Re: MCPC #19-0007-002
Plan Name: 2750 Morris Road – Building “D” South
(1 lot comprising 81.01 acres)
Situates: Moore Road and Schultz Road
Worcester Township

RE: RESPONSE LETTER – TRAFFIC REVIEW #1
2750 Morris Road – Amazon Proposed Parking Facility
Worcester Township, Montgomery County, PA
TPD Job #ARMI.00001
McMahon Project #819940.11

Amazon Parking Facility
Transportation Impact Assessment
Worcester Township, Montgomery County, PA

Attachment 1: Reduced Copy of Plan

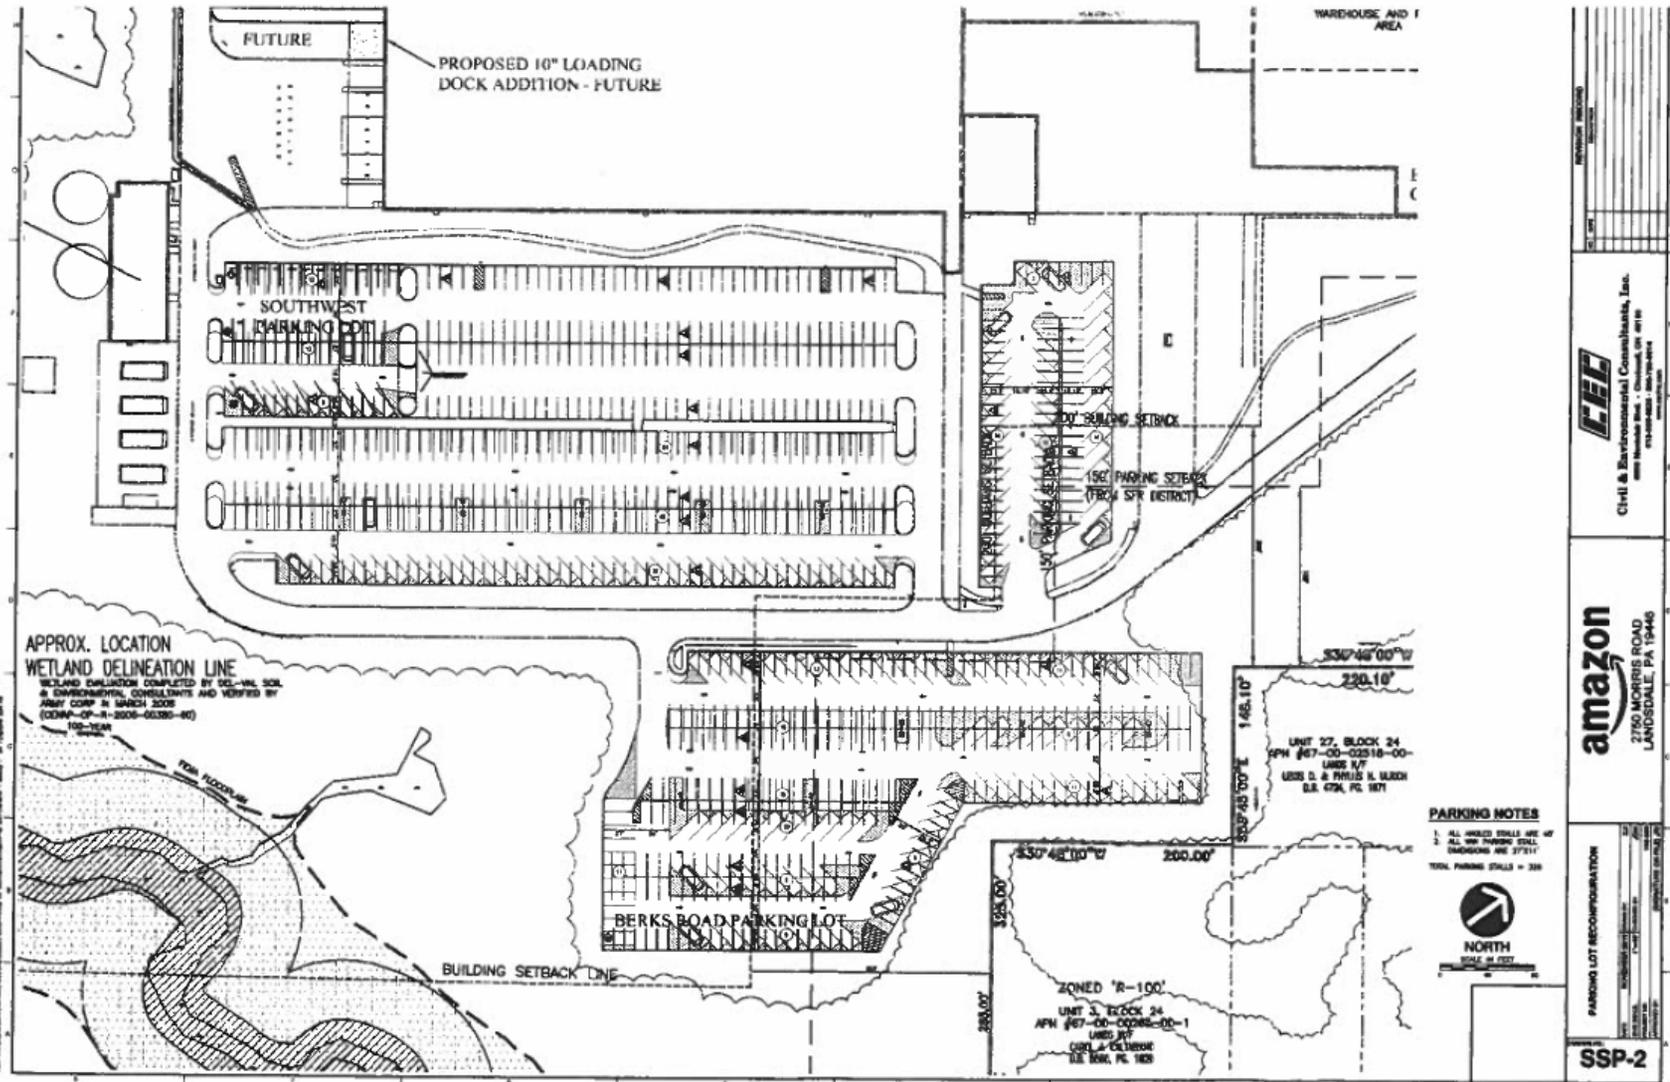
2. Parking Capacity. The Applicant should document on the plans the existing capacity of all parking on the site and certify that the required parking, according to the existing occupied and vacant building space as per the Zoning Code, is maintained on the lot.
3. Designated Routes. The Township may wish to work with the Applicant to identify specific routes from the Towamencin facility to this parking lot, in order to reduce cut-through traffic through residential areas. In addition, such identification would indicate which roads and intersections would most be affected by the increase in trips in this part of the Township, refining the Traffic Impact Study results.
